County of Fairfax, Virginia

STAFF REPORT ADDENDUM

APPLICATION RZ 2014-PR-018

Given the foregoing, the applicant has therefore revised their General Development Plan (GDP) to depict a maximum of three (3) homes on the parcel. This GDP, entitled "2701 Chain Bridge Road" as prepared by BC Consultants in July 2014 as revised through May 2015, access would still be on a private shared driveway from the existing service drive along Sutton Road and the homes remain generally oriented toward Chain Bridge Road. Some of the key changes are shown in this chart which depicts that the proposed lots are now larger and the overall density has been reduced.

GRADING PLAN
 GENERALIZED DEVELOPMENT PLAN
2701 CHAIN BRIDGE ROAD
 PROVIDENCE DISTRICT
 FAIRFAX COUNTY, VIRGINIA

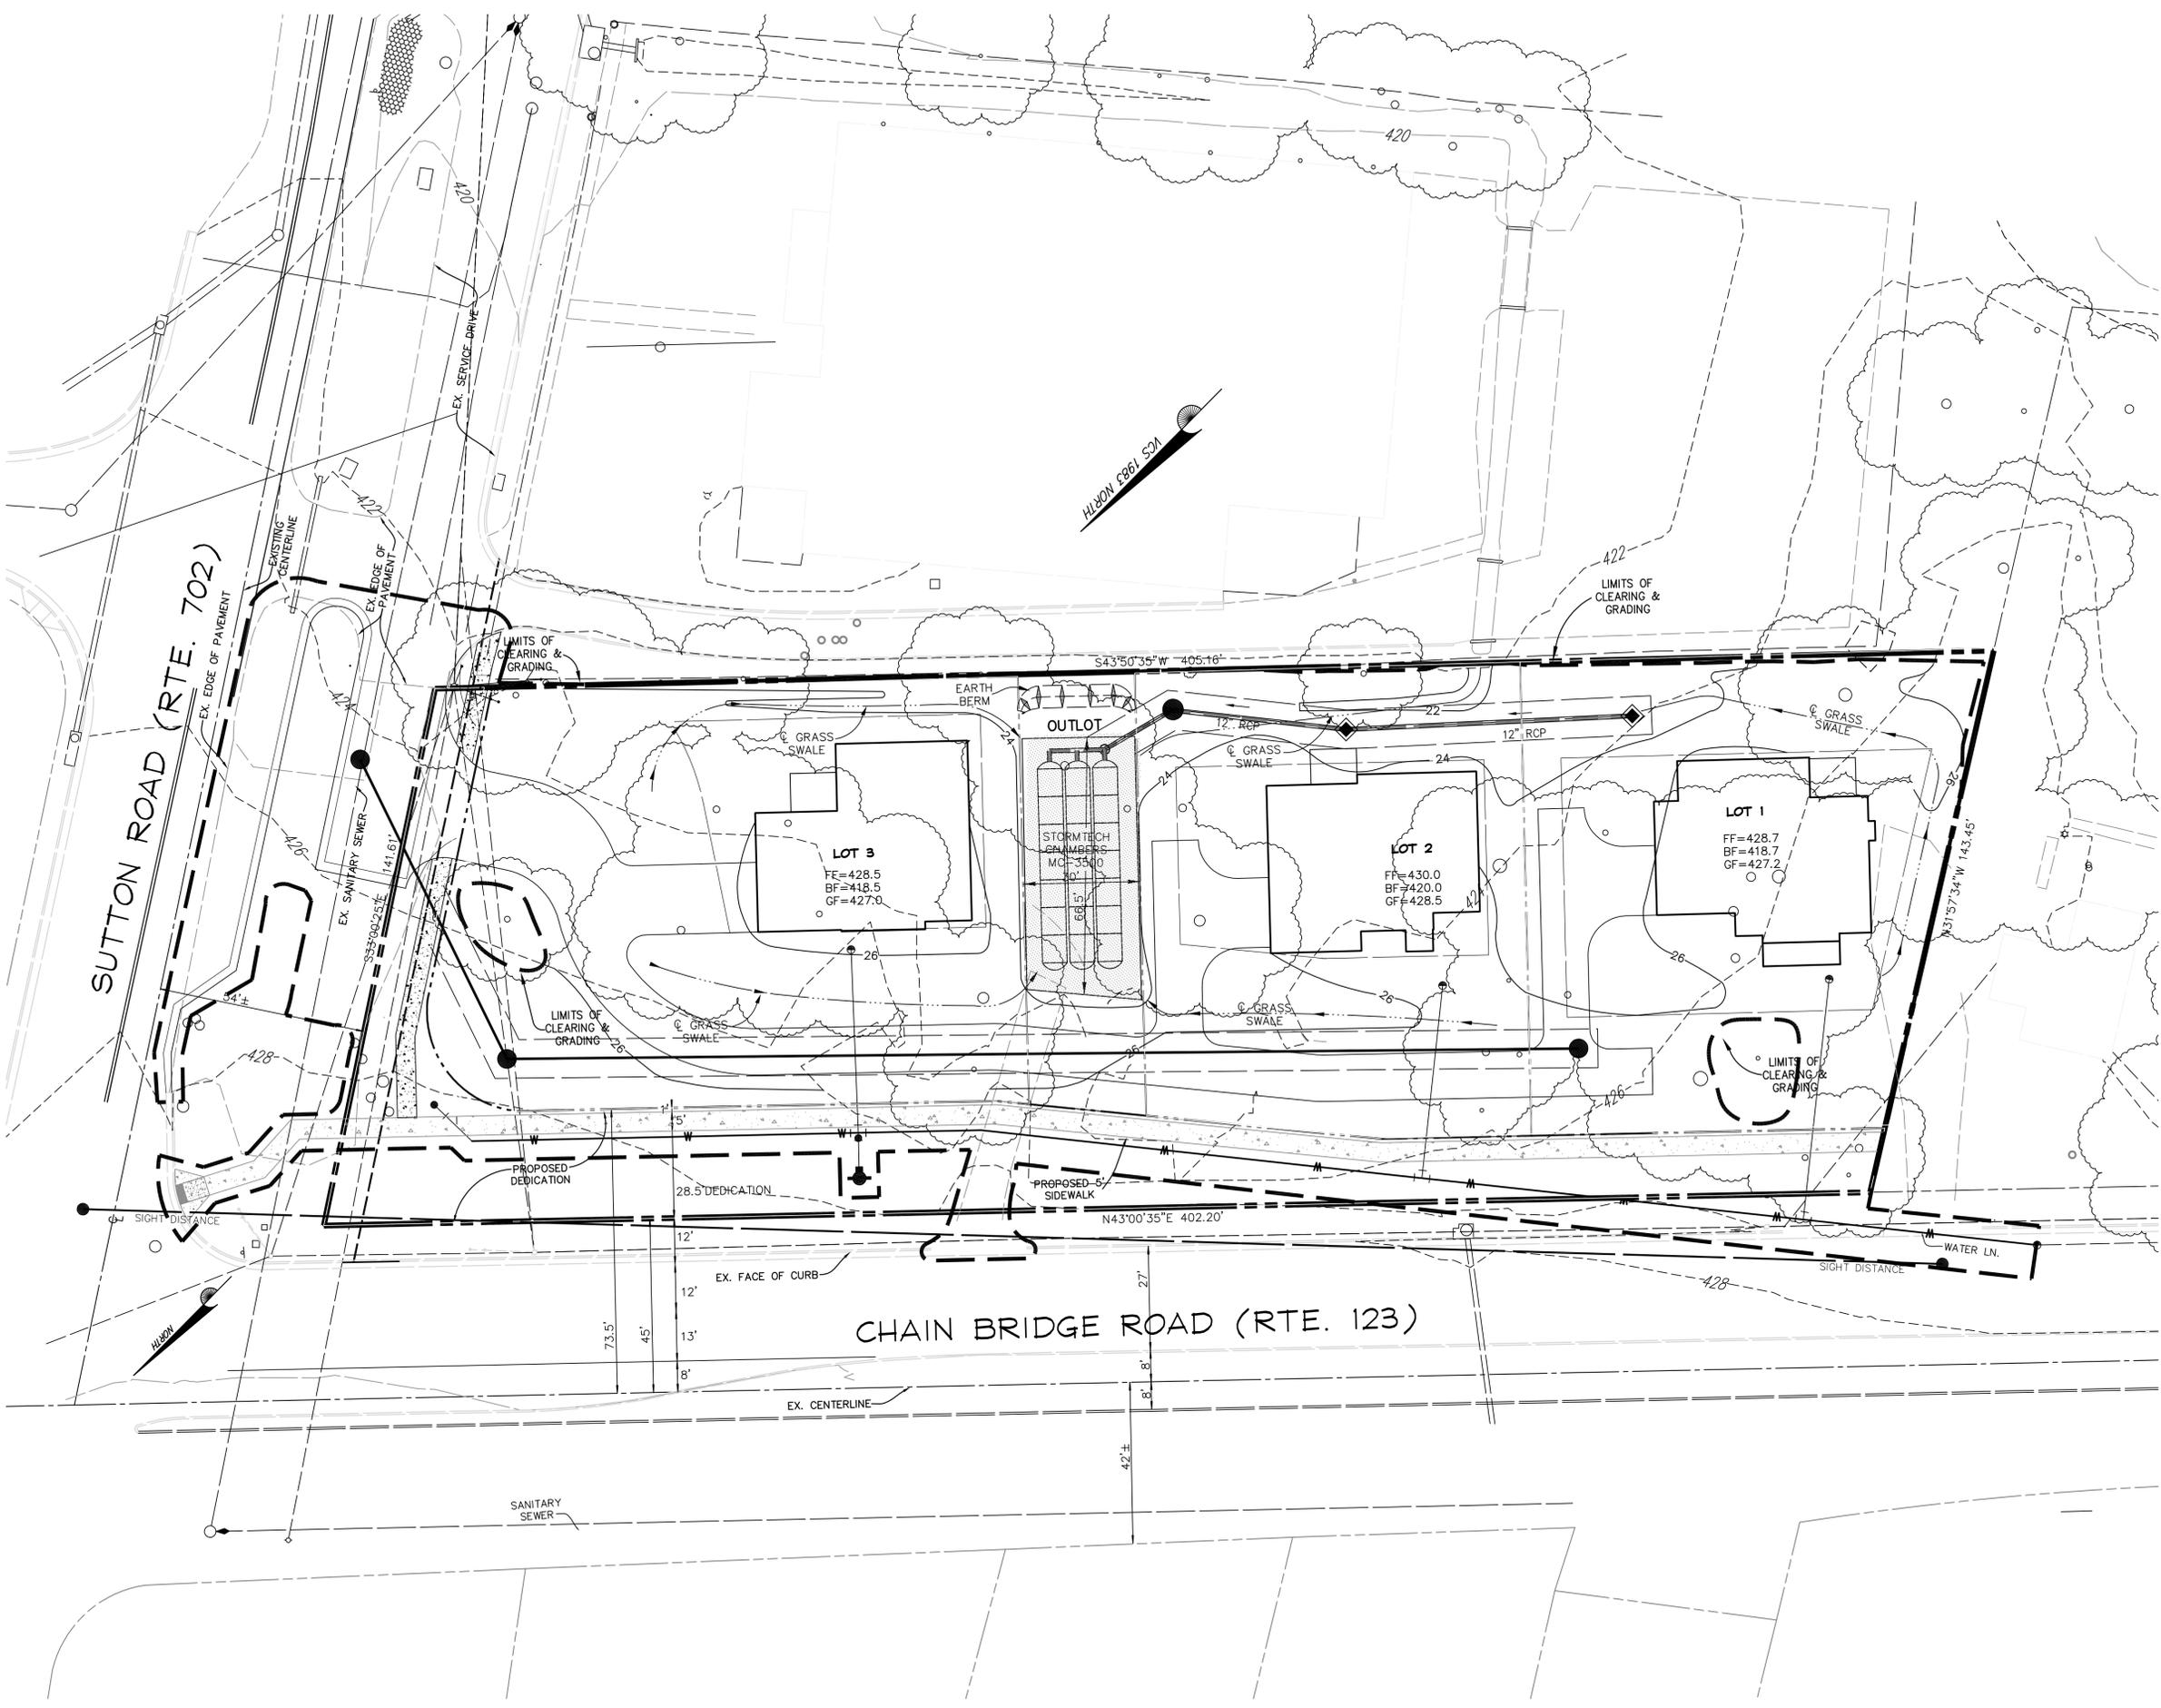
with site plan submission. To assure that interior noise levels were no greater than 45 dBA and exterior noise levels were not greater than 65 dBA, the applicant agreed to provide mitigation in the form of acoustical walls or fencing on Lots 1 and 3. However, while the proffer remains unchanged, the applicant has still not depicted the walls on the new GDP. Staff recommends that these walls or fencing be depicted on the GDP.
